**Coal Combustion Residue Impoundment
Round 11 - Dam Assessment Report**

*Watts Bar Fossil Plant (Site #12)
Old Ash Pond and Stilling Basin
Tennessee Valley Authority
Spring City, TN*

Dewberry Consultants LLC
Fairfax, Virginia

Under Contract Number: EP-09W001727
January 2013(Revised April 2013)

Figure 2.1-2: Aerial Photograph

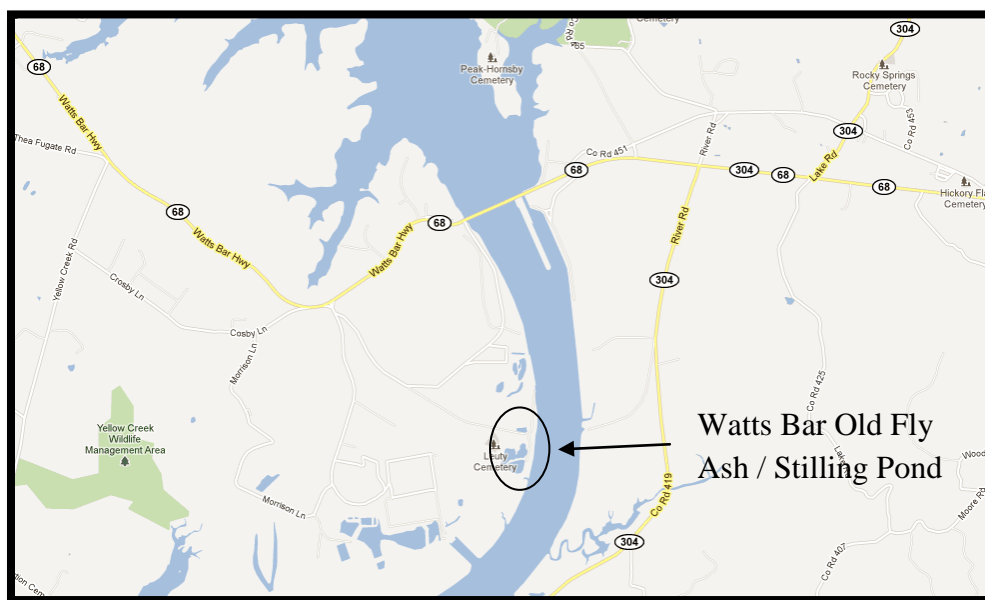
EPA Comment 6: Figure 2.1-2: Aerial Photograph is inadequate. The scale of the photo is not detailed enough. This becomes an issue when attempting to determine the perimeter of the CCR unit. Additionally, the call out in the Figure states “Dry Flay Ash...” – Please correct the typo.
